TRUCK, UTILITY, LIGHTWEIGHT, FFR, MC2 - LANDROVER 110 - ALL TYPES
TRUCK, UTILITY, LIGHT, FFR - LANDROVER SERIES 3 - ALL TYPES
TRUCK, CARGO, LIGHT, FFR, MC2 - LANDROVER 110 - ALL TYPES

REWIRING OF THE 28V VOLTMETER CIRCUIT

MODIFICATION INSTRUCTION

FIG 1 - CIRCUIT DIAGRAM OF 100A 28V DISTRIBUTION SYSTEM (SERIES 3)

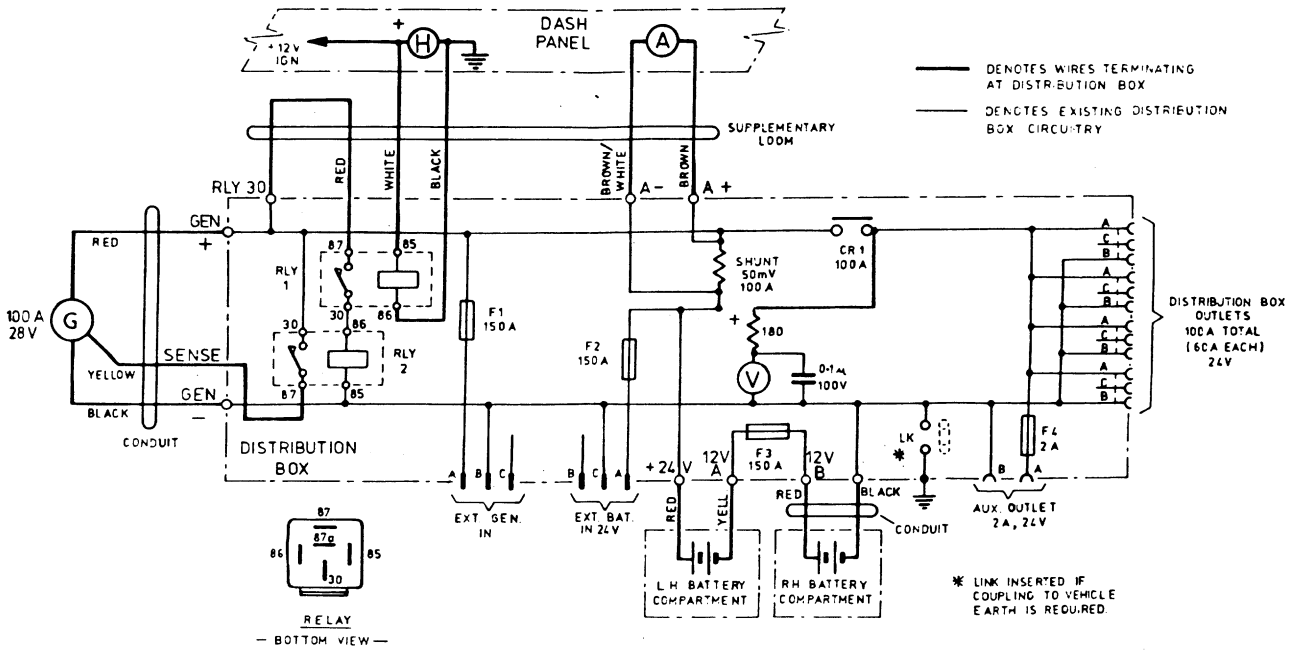
1. This instruction details the rewiring of the voltmeter circuit in the distribution box of the subject vehicles to prevent the batteries from slowly discharging when the vehicle is not in use.

7. The modification is to be carried out as detailed below:
 - a. Disconnect the radio batteries.
 - b. Remove the front cover from the distribution box and remove the main switch from the cover.
 - c. Disconnect the voltmeter sense wire, cut off the connector, strip 10mm of insulation from the wire end and re-connect the wire to the switched side of the main switch.
 - d. Refit the main switch to the front cover and refit the cover to the distribution box.
 - e. Re-connect the radio batteries and test the operation of the voltmeter. The meter should indicate radio battery voltage with the main switch in the ON position only.
8. Modification Record Plate. Deface the numeral 2 on the modification plate located under the lid of the distribution box.
